ALAMEDA POINT PROJECT

Response to Comments on the
Draft Environmental Impact Report
SCH No. 2013012043

Prepared for
City of Alameda

December 2013

Posey Tube Outbound = $894 + 1787 = 2681 \text{ vph}$

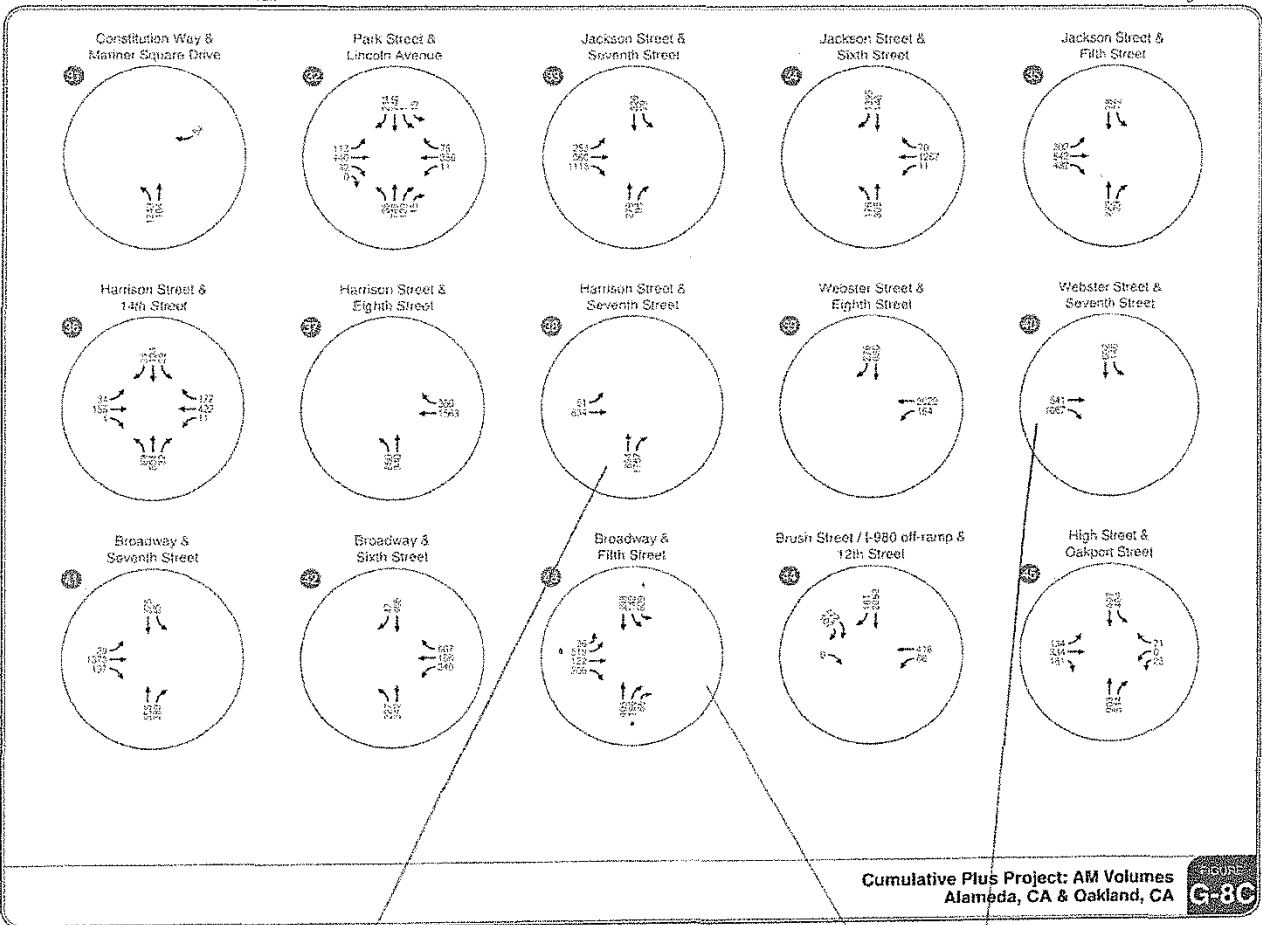
Another example of a flaw is the outbound traffic into the Posey tube will be 2681 vehicles per hour in the AM Peak hour after the Alameda Point Project in the year 2035 which would be lower than existing recorded traffic counts at the Posey tube since the Base closure. That too is illogical and not explained in the DEIR.

SOURCE: The Department of the Interior Alameda Point Project . 130025
Figure 3-4
 NAS Alameda Historic District (Revised)

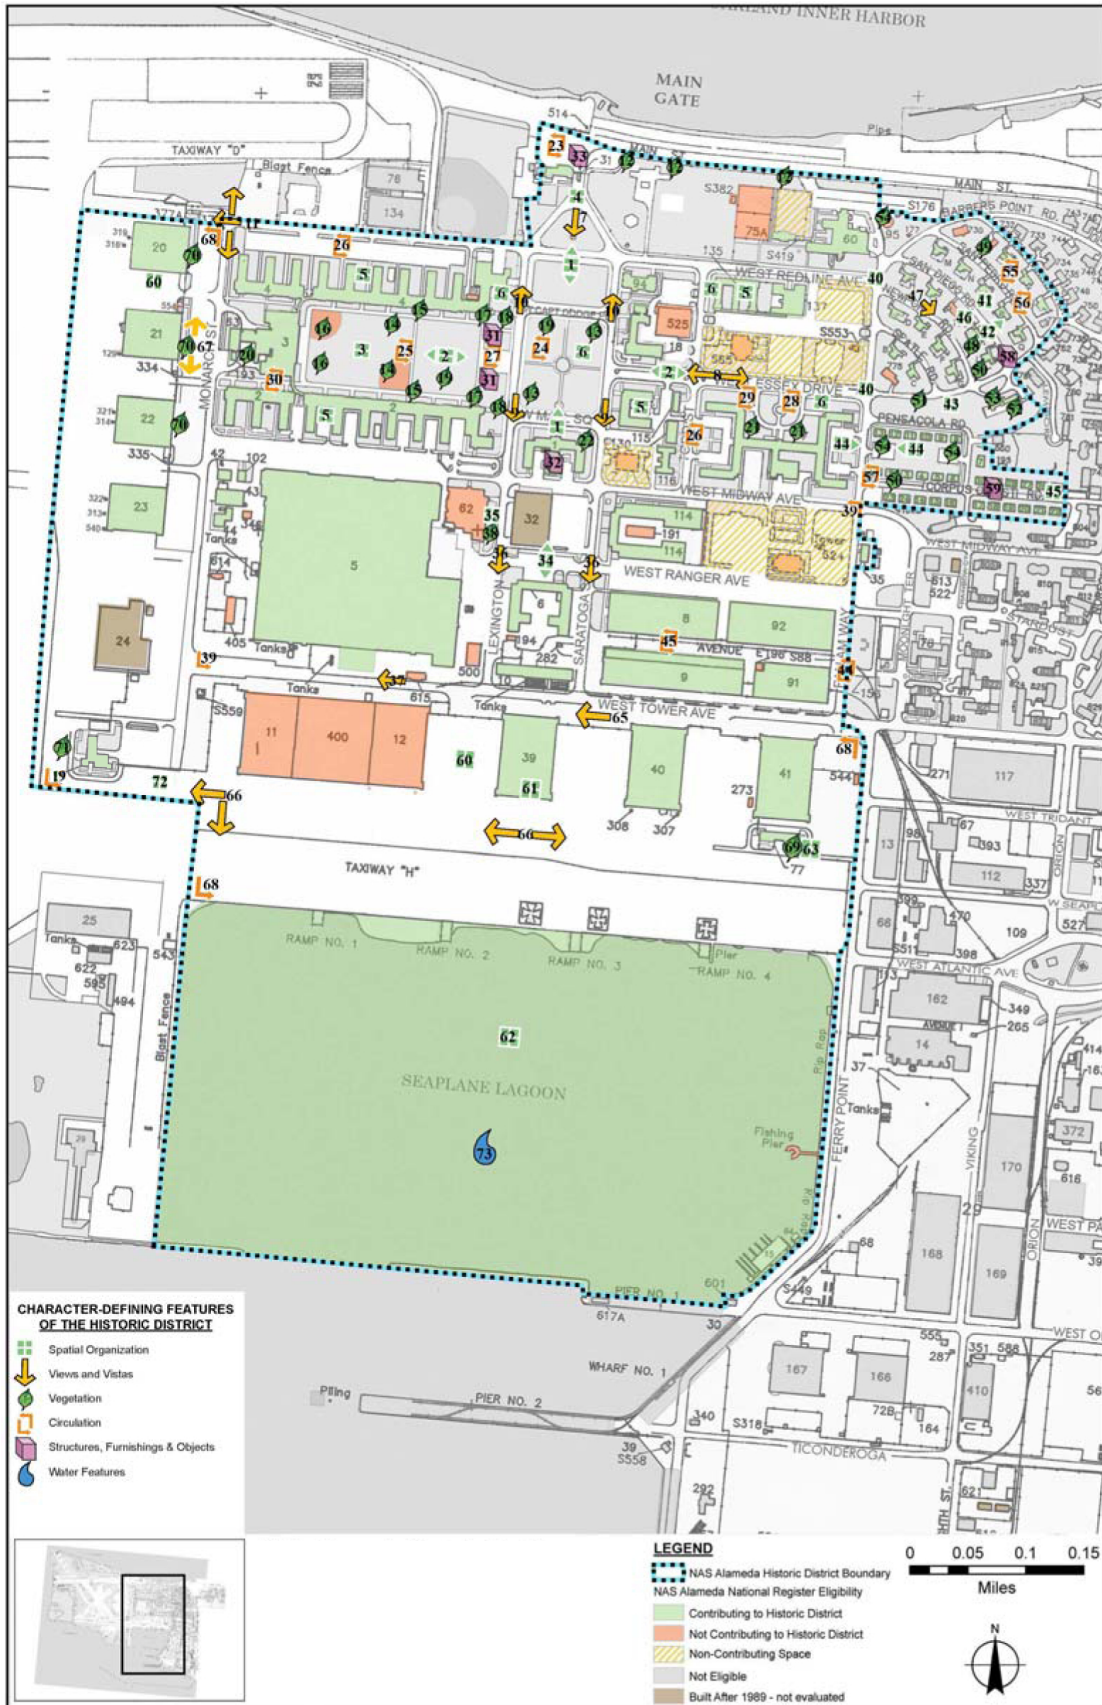
2. **Chapter 3 Figure 3-4, page 3-13** – this map was originally published in the Cultural Landscape report. This map has an error; the Tower (Bldg 19) is shown as a non-contributor to the Historic District. This information is incorrect. The Tower was identified as a contributor to the Historic District.

Figure 3-4 on page 3-13 of the Draft EIR is corrected to show the Tower (Building 19) as a contributor to the NAS Alameda Historic District, as shown on the following page.
